工程指示 / 要求簡箋(E.I.)

工程指示編號 : EI / 7946 / 24 修改版次 :
 工程編號 : J - 858 工程名稱 : 日出康城 LP 11
 工程項目 : 趟門 T2 T3 AF (67/F) 圖紙上載 拆圖
 收件人 : 生統 / 拆圖 發件人 : Ant Yeung 日期 : 18/06/2024

TITLE : PENTHOUSE FLOOR PARTIAL ELEVATION & SECTION, PLAN FOR CURTAIN WALL (TOWER 2)

DWG NO. : J858-CW-PE220 REV. : G

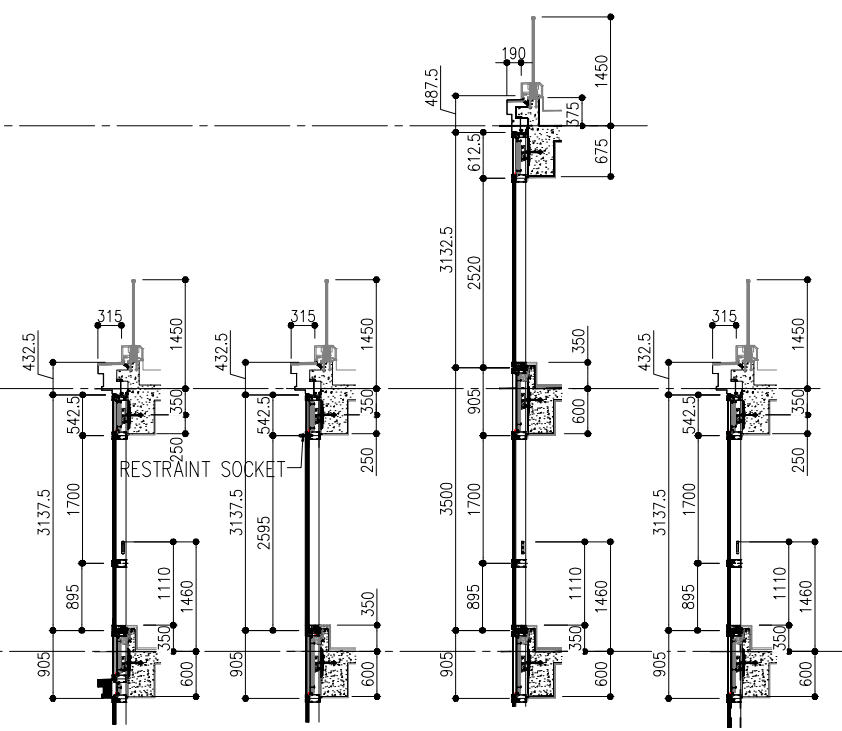
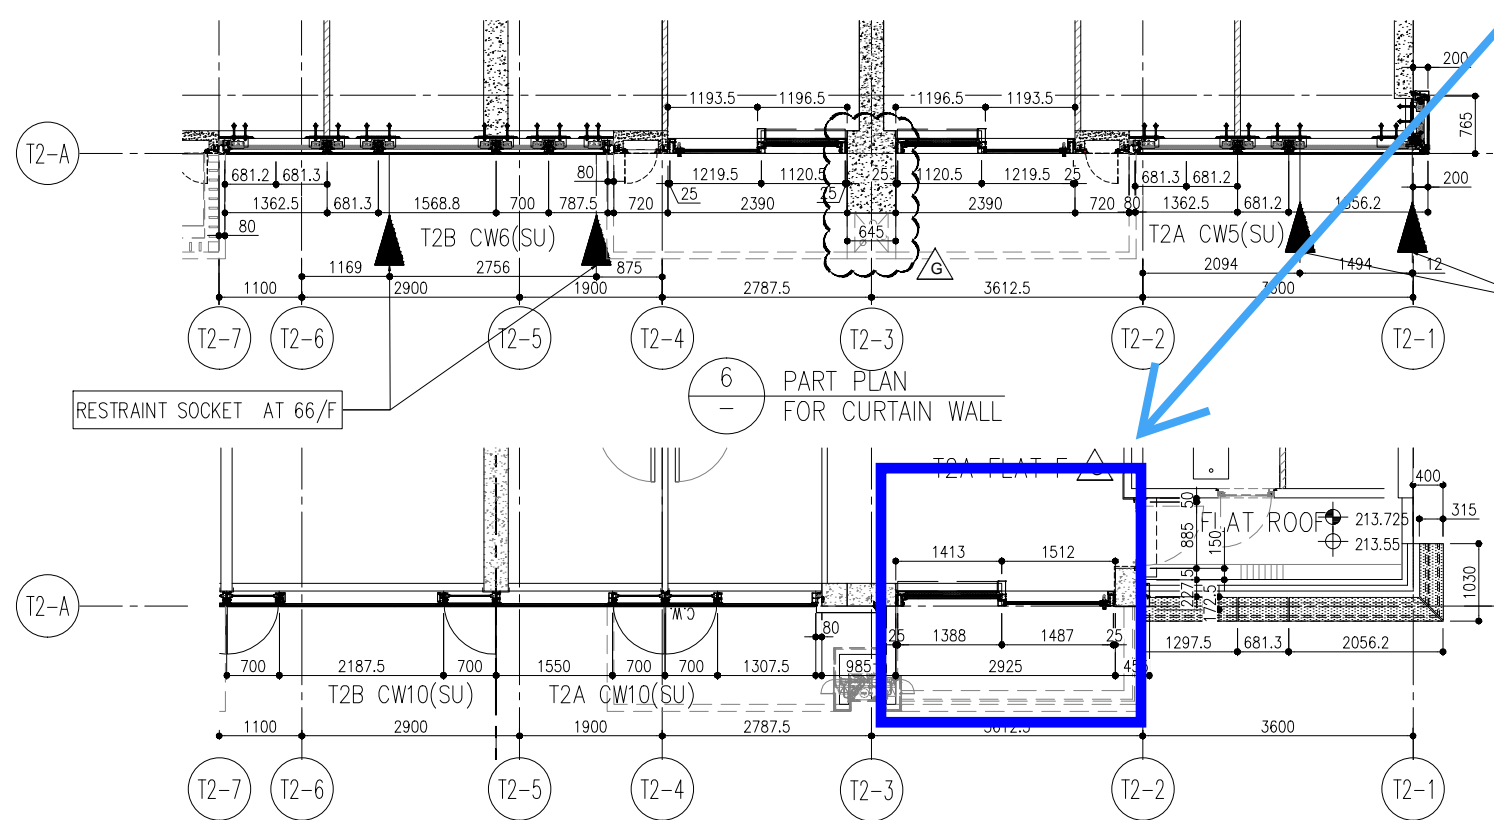
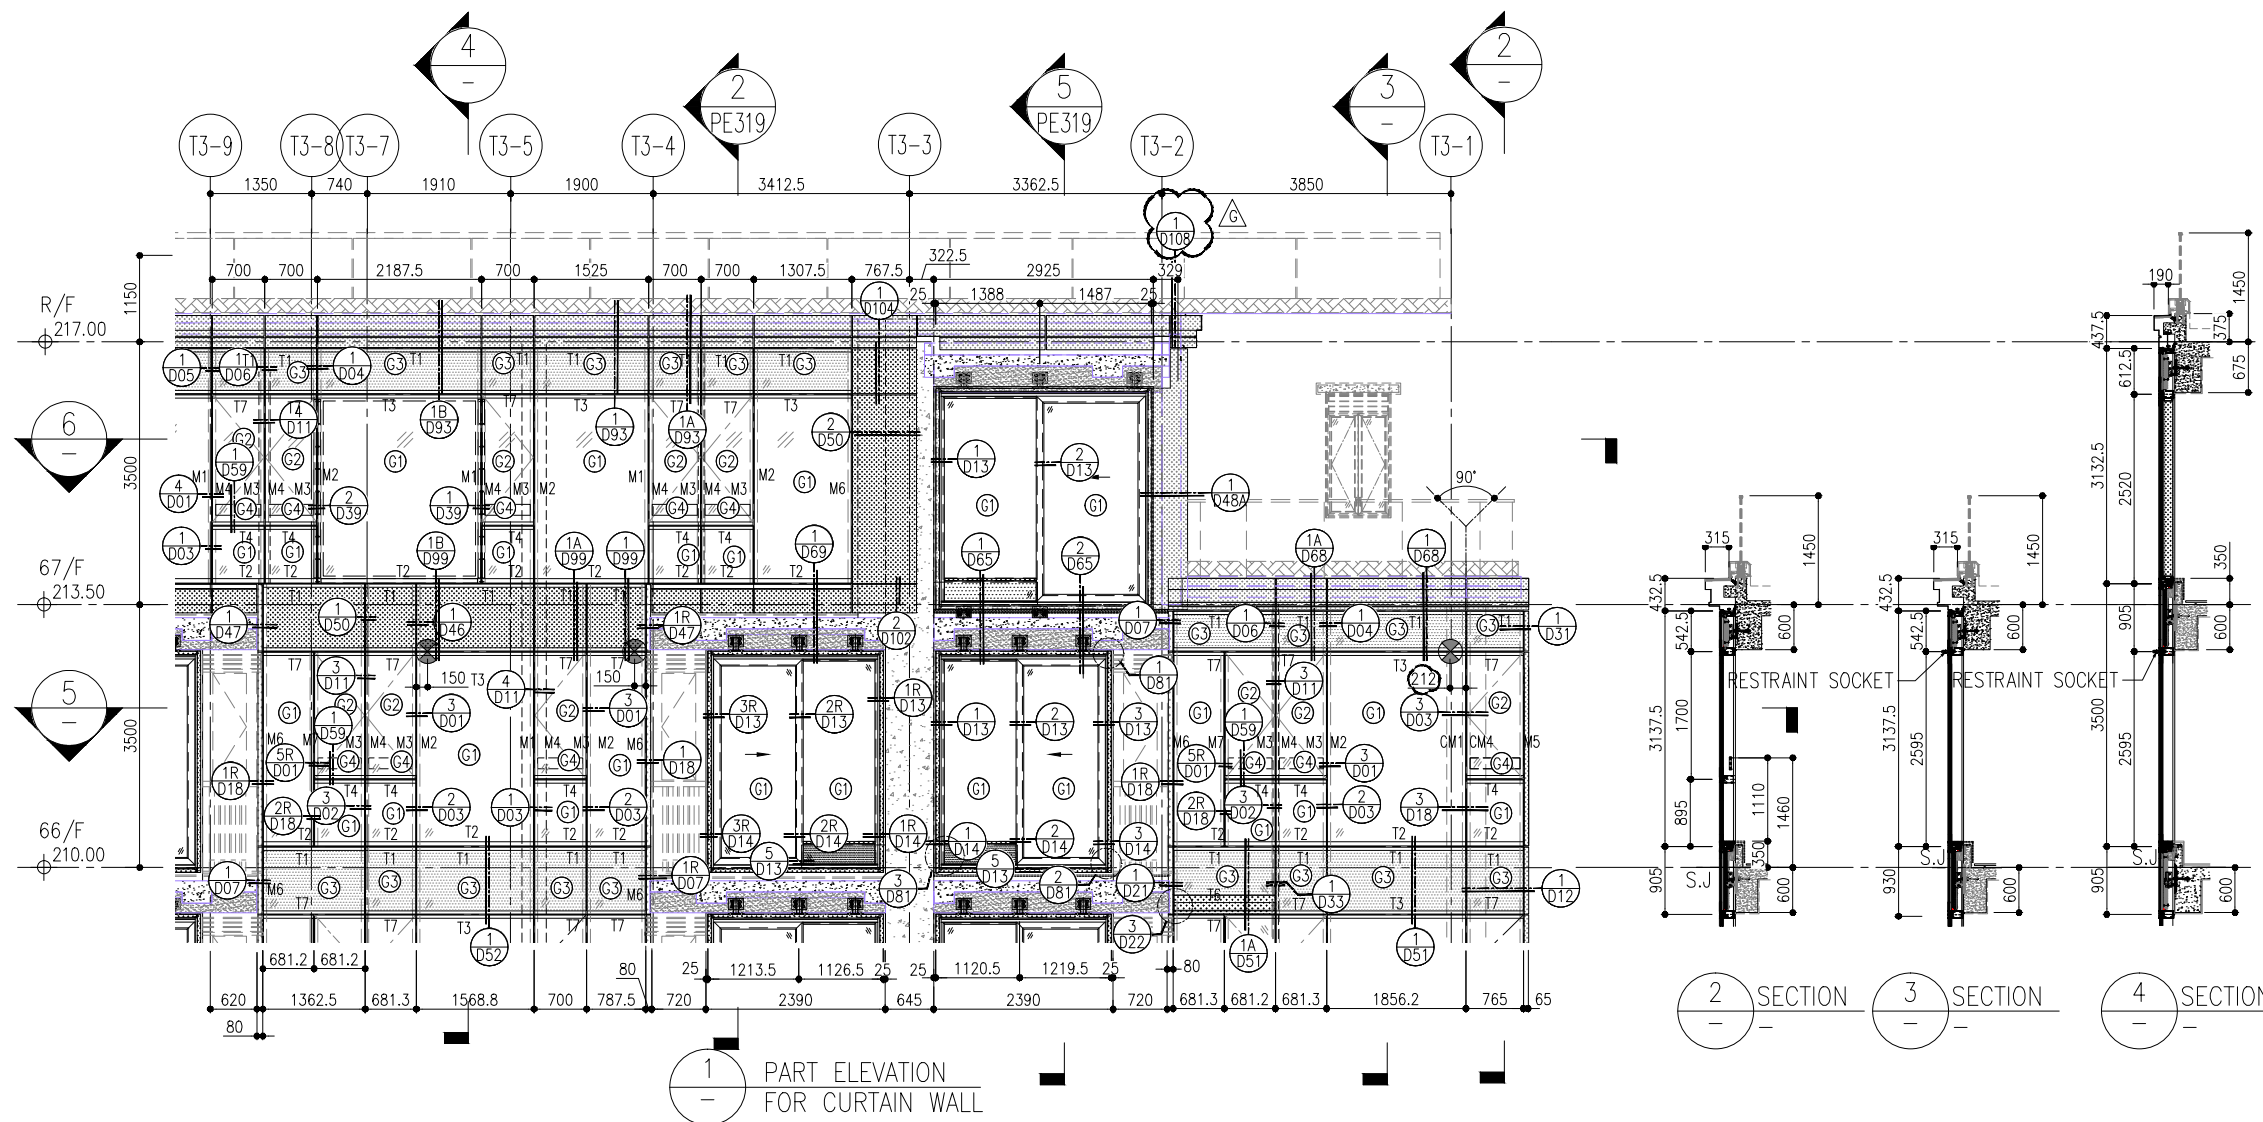
因應 9 號幕牆大圖已批，已拆圖生產<3040mmW S.O>，其後則師圖更改 GBP 的。導致生產和現場的石矢不吻合。需要重新拆圖生產。

請安排拆圖 2 幅趟門 (T2 A-F , T3A-F) (67/F) <2925mmW SO>

T2 A-F

- 1/ Structural S.O. for T2A-F-L-1 and T3-AF-L-1 curtain wall shall be 2925 mm to tally with GBP.
- 2/ GECCL should be well aware of such column size changes, which would affect Midi's work. Waterproofing problem would be an issue if concrete hacking work is proposed from GECCL/ Midi.
- 3/ RFI/S/1566 refers. Site works have been carried out to rectify such discrepancies to facilitate OP inspection in late July, 2024. No further concrete hacking should occur.
- 4/ Poor coordination and drawings checking between GECCL with NSC. Please check all information in approved GBP drawings.
- 5/ For curtain wall sliding doors that are unfit to be installed on site, please proceed with ordering of material asap.

DWG NO. : J858-CW-PE320 REV. : G

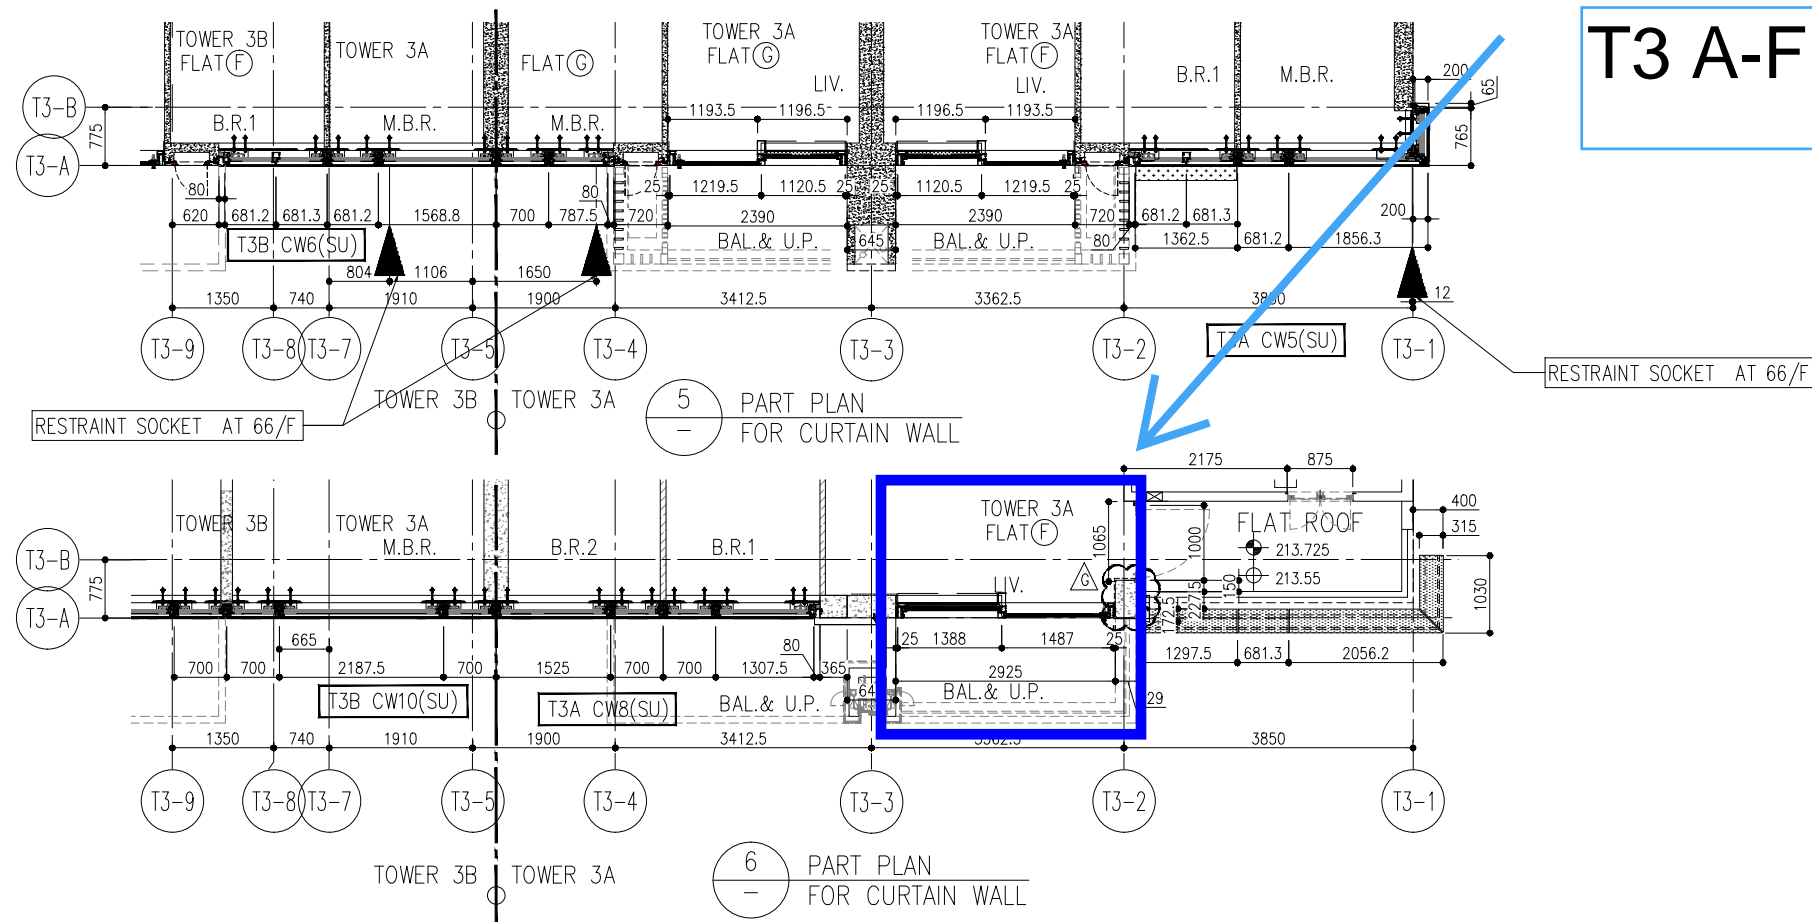
T3 A-F
